Approval Sheet

PART NO.: SA130D-12U (replace 69-797-52)

DESIGN NO.: A130D15404-2

CHANGE NOTICE

REV.	DESCRIPTION				DATE\REVISER		DWG. NAME	
	DRAWER	DESIGN	CHECK	APPROVED	Q'TY	UNIT	MODEL	DC CORD
						MM	MATERIAL	P.V.C
						1/1	TREATMENT	
							DWG. NO.	S89-C3BXX8-1Z/
							ORIG. DATE	2015.09.08
							MANUFACTORY	
ONTOP ELEC. CO., LTD.

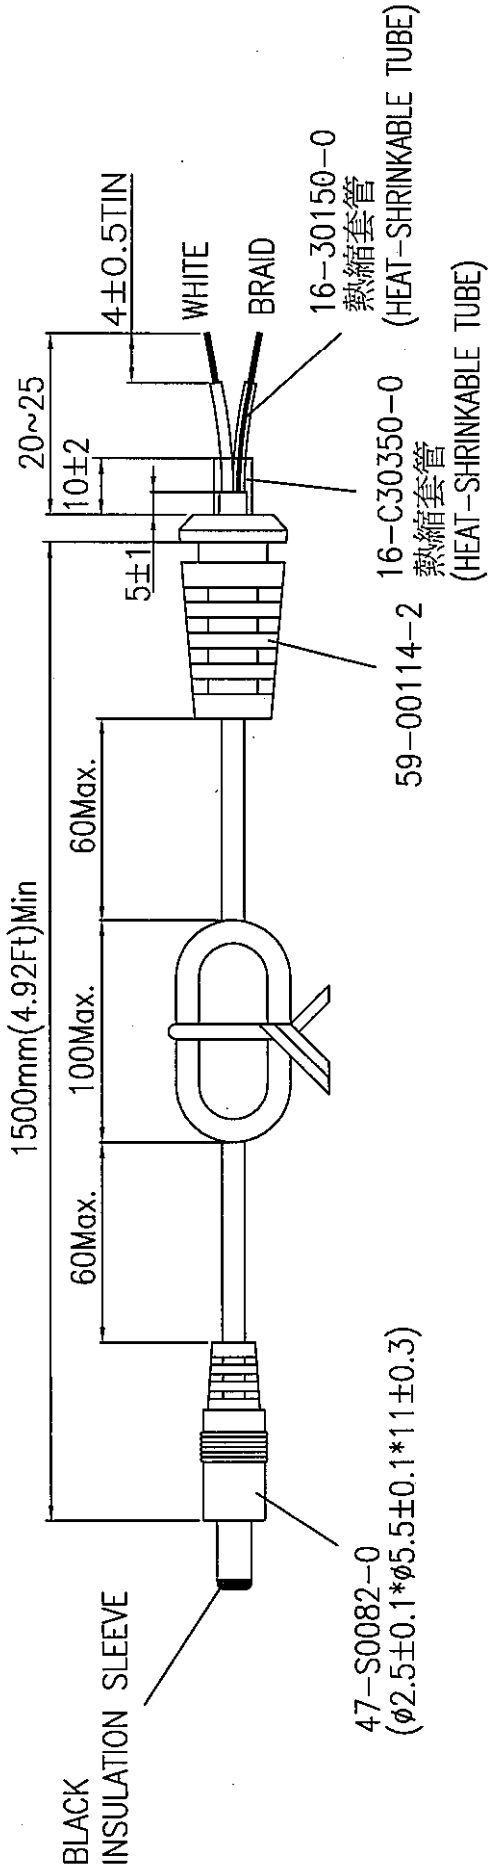
REMARK: change dc plug size to 5.5x2.5x11mm

ORIGINAL DESIGN NO. A130D15404-1	REVISED DESIGN No. : A130D15404-2
DC PLUG : 2.1*5.5*11 S	DC PLUG : 2.5*5.5*11 S
Customer Approved by : _____

REV.	DATE	BY:	DESCRIPTION OF CHANGE
-2	29-Oct-15	Customer	Change the DC PLUG .

8-3 Output Cable : 1500mm UL 1185 AWG18*2C , with Plug : 2.5*5.5*11 S
Polarity : Center "+"
